Sub: RDSO modification sheet no. RDSO/2011/EL/MS/0394 dated 09.02.2011 for electric locomotive auxiliary circuit for isolating complete air conditioner circuit in case of earth fault in air condition unit.

MODIFICATION SHEET NO. RDSO/2011/EL/MS/0394 Rev '0' Dated: 09.02.2011

Modification in electric locomotive Auxiliary circuit for isolating complete Air conditioner circuit in case of earth fault in air condition unit.

| REF. | PART NO. | DESCRIPTION | DETAIL DRG. NO. | NO./LOCC | HAUT. | SPEC. |
|---|----------|-------------|-----------------|---------------------|---------------|----------|
| SKEL-4845 | | | | | SUPERSEDED BY | |

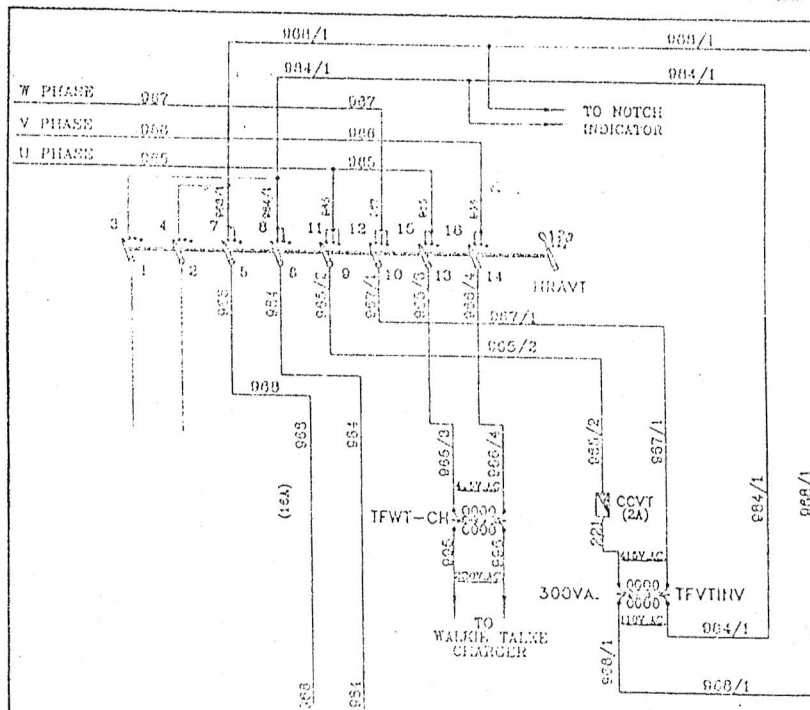
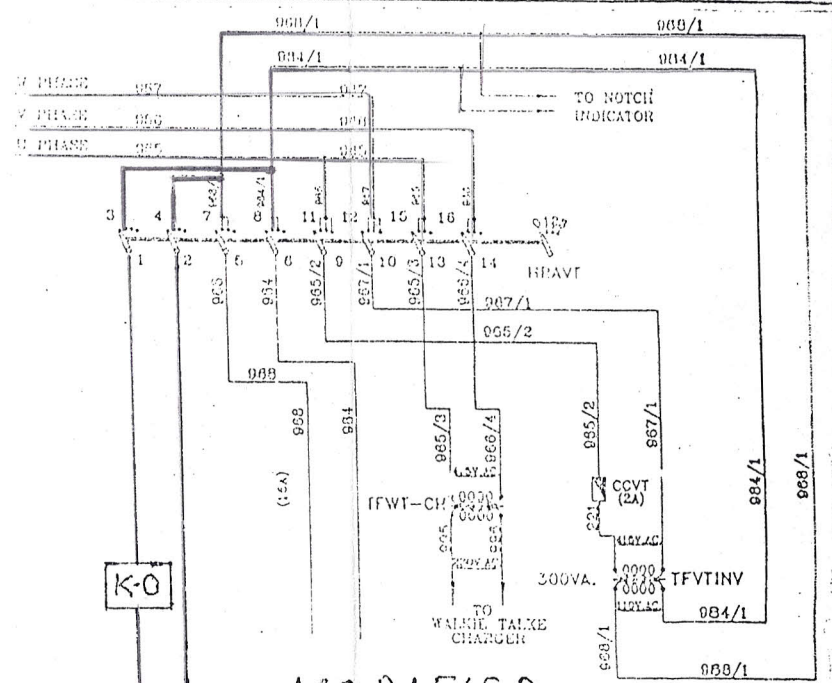
One 32A contactor (K0) is to be in the auxiliary circuit of SIV contactor should be fitted in back side of TK panel in cab-2 side. Two spare toggle contacts (pole nos. 1,2) of HRAVT programme switch at position 2 is to be used for isolating contactor (K0) for air conditioner.

The modified circuit arrangement is shown in RDSO Drg. No. SKEL-4845 in place of existing circuit arrangement of CLW Drg. No. CLW.3W.15000.004 sheet no. 17 of 21. In case of earth fault complete air conditioning system can be isolated through HRAVT. The positions of programme switch HRAVT in modified arrangement is as shown below:-

| REF. | PART NO. | DESCRIPTION | DETAIL DRG. NO. | NO./LOCC | HALT. | SPEC. |
|---|----------|-------------|-----------------|------------------------------|--------------|----------|
| RDSO. ELECT. DTE. | | | | SKEL- 4844 | SUPERDED BY | |

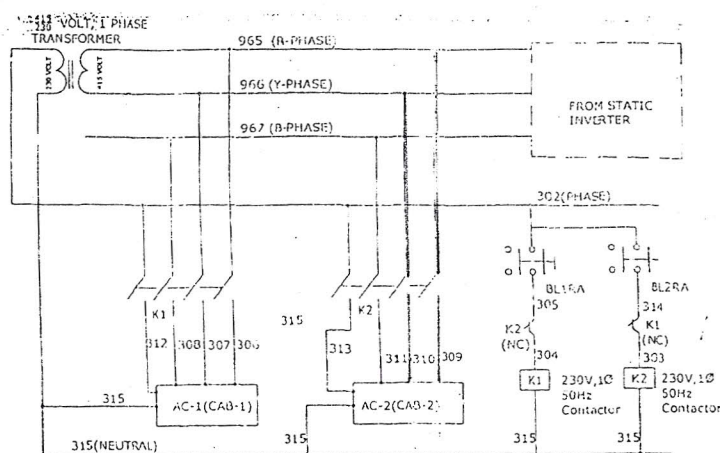
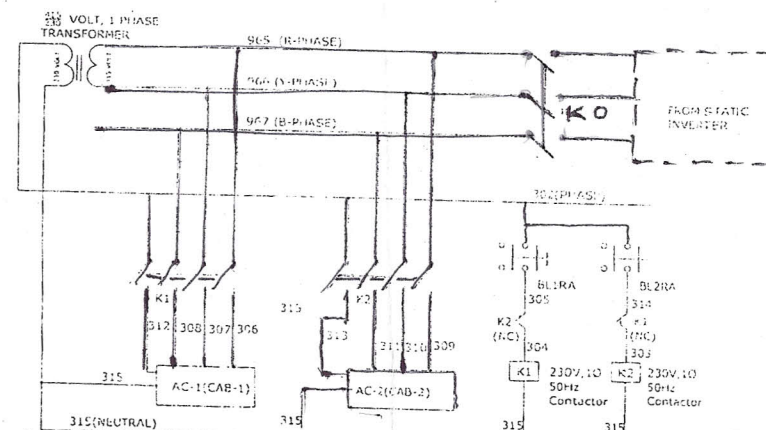
In CLW Drg. No. CLW.3W.15000.004 sheet no. 19 of 21. 3 contacts of K0 isolating contactor are to be used with wire no. 965 (R-phase), 966 (Y phase) & 967 (B phase) in 3-phase output of Static inverter as per modified drg no. SKEL-4844.
